From: [Hart, Liam](#)
To: [DBE - PLN Support](#)
Subject: FW: 17/01207/FULMAJ Objections
Date: 15 January 2018 11:04:55

Address: Creed Court 3 - 5 Ludgate Hill, 1 - 3 Creed Lane And 11 - 12 Ludgate Square London EC4M 7AA

Proposal: Application under Section 73 of the Town and Country Planning Act 1990 to vary condition 49 (approved drawings) of planning permission dated 06 October 2017 (ref: 14/00300/FULMAJ) to enable (i) removal of third basement level; (ii) internal reconfiguration to create 152 hotel rooms and associated alterations to the fenestration on Ludgate Square and Creed Lane; (iii) relocation of the UKPN sub-station from basement to ground floor level; (iv) reduction in A3 (restaurant) floor area from 1,028sq.m to 478sq.m and relocation of the restaurant entrance door to Creed Lane; (v) reconfiguration of the waste storage facilities and service area; and (vi) other minor internal and external alterations.

Fig 1

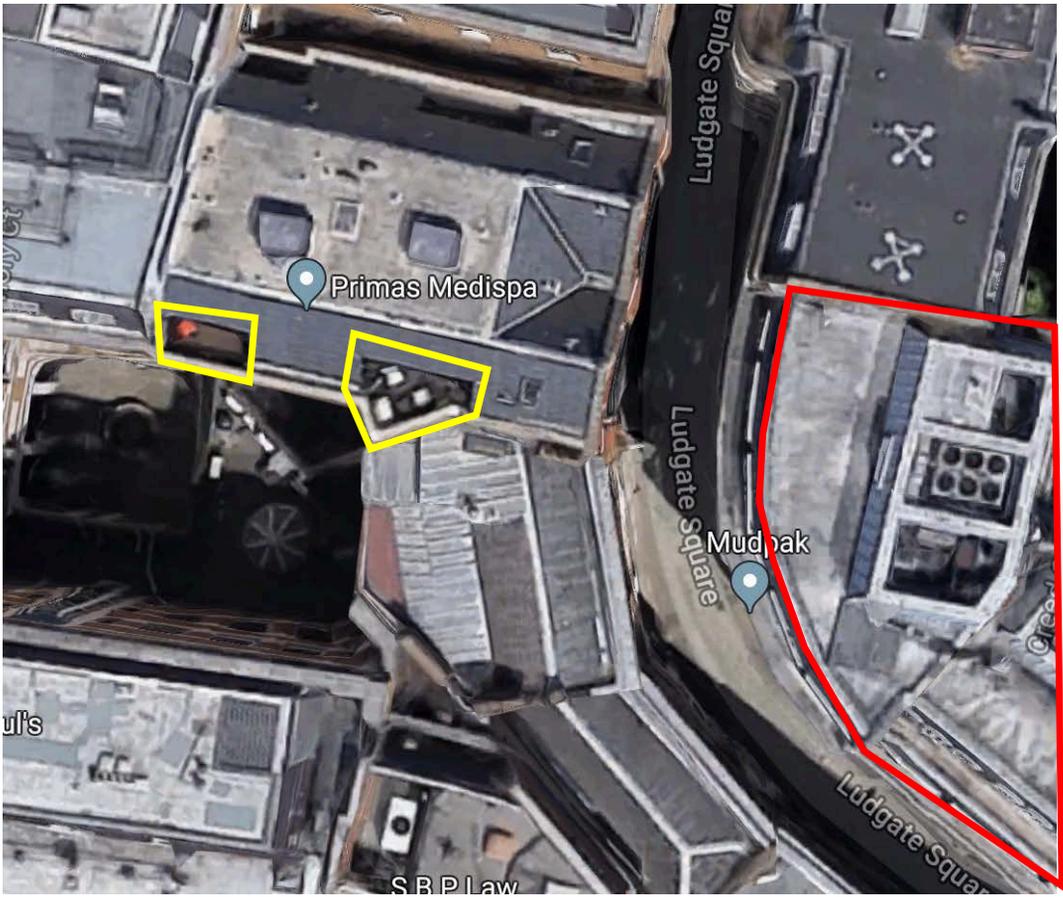
Please refer to the photographs, Figs 1,2,3,4 on the following pages for a compelling illustration, in addition to your personal knowledge of the site, of the affect that this proposal would have.

- Outline of proposed 6th floor accommodation
- Outline of Flat 22, 3 Ludgate Sq. amenity terraces

Fig 2

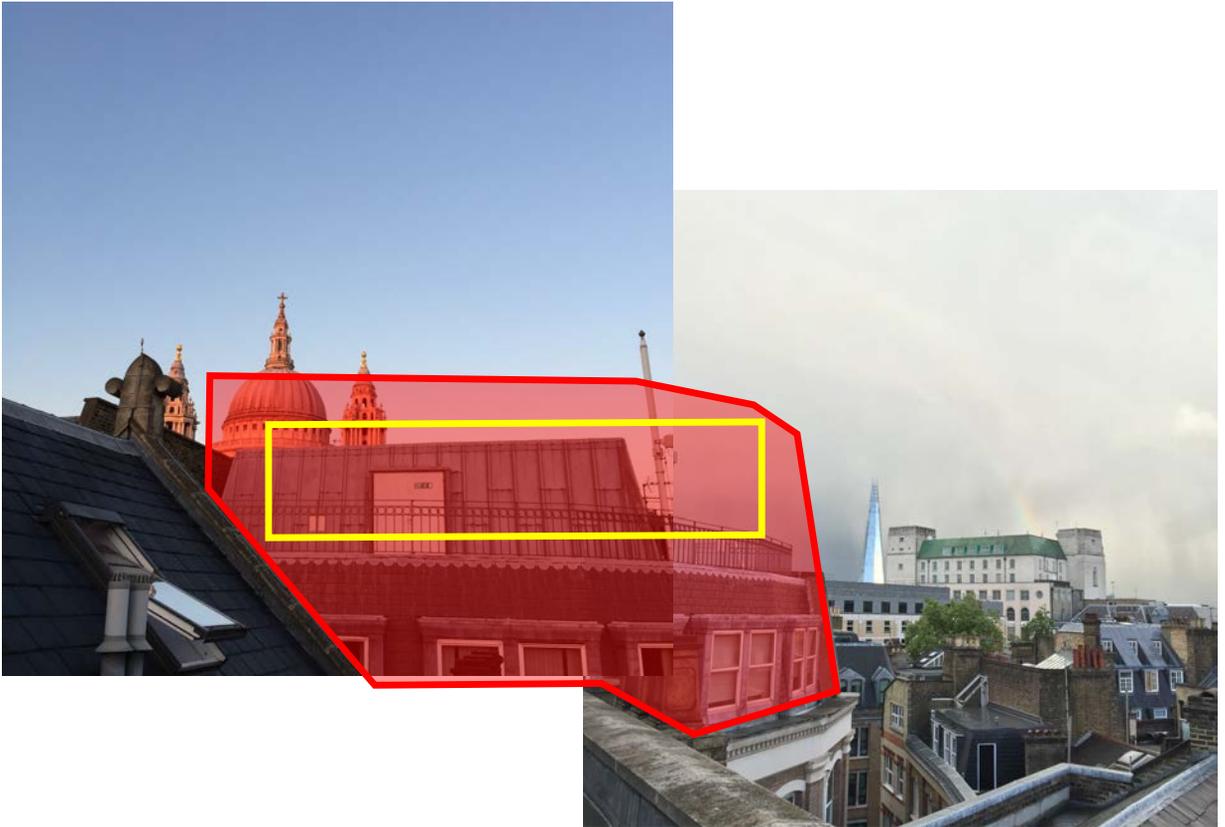
Daytime view from Flat 22, 3 Ludgate Square living room terrace.

Note the overshadowing and loss of visual amenity attendant on the increased bulk and height (outlined red) - which although estimated will certainly be higher than the existing plant floor on the current building.

Note particularly the egregious loss of privacy from the proposed new windows (approximate position outlined yellow).

Fig 3

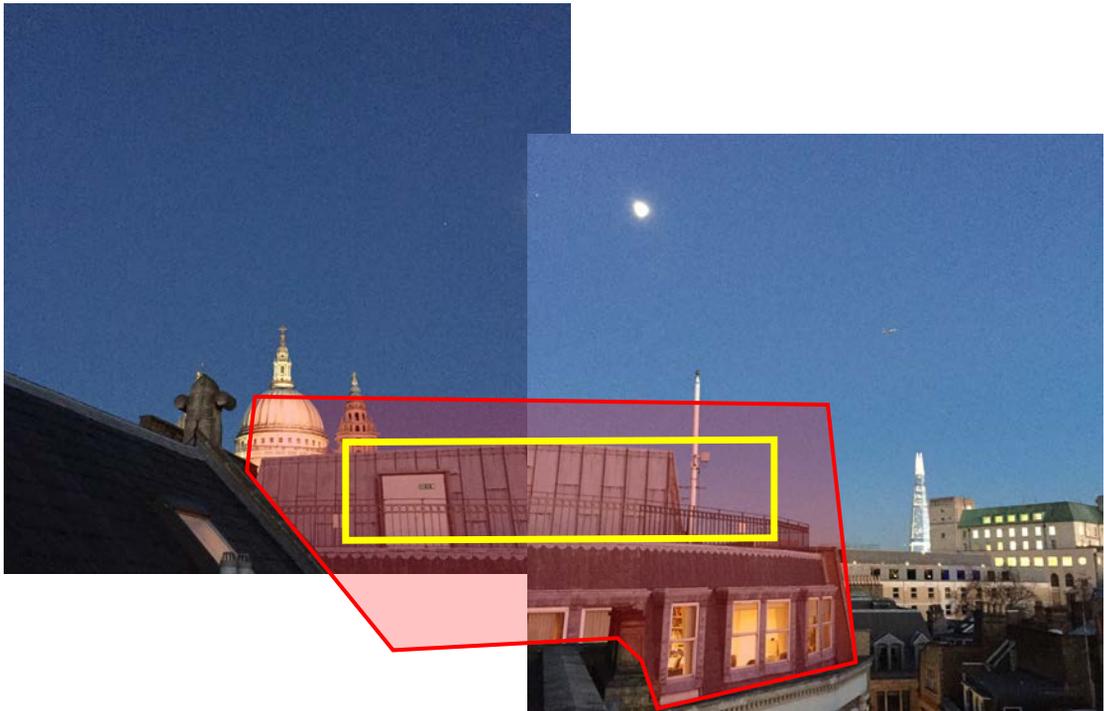
Night time view from Flat 22, 3 Ludgate Square living room terrace.

As fig 2, additional note on how lighted windows (as we can see here on the lower floor of the existing building), will at night create a sense of being extremely overlooked. We would be able to see directly into the lighted hotel bedrooms and anyone in these rooms would be practically eyeball-to-eyeball with us, just a few metres away.

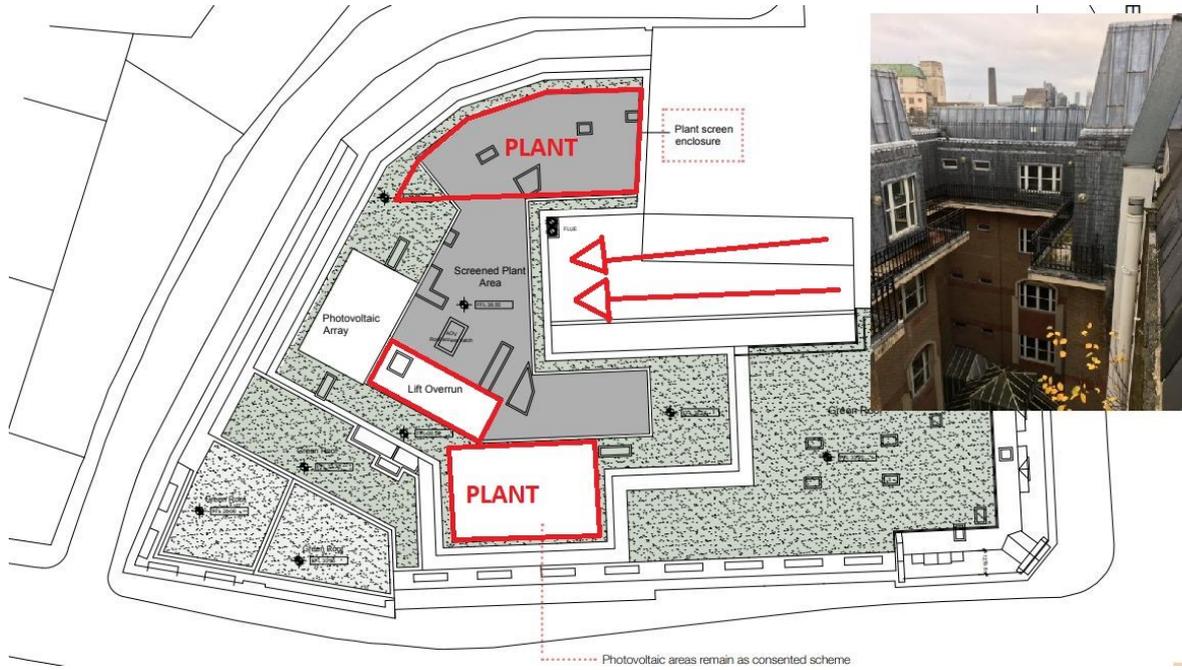
We object to this point which is detailed above and we welcome the proposed roof plant room redesign in line with the proposal attached.

We also await the schedule of proposed plant?
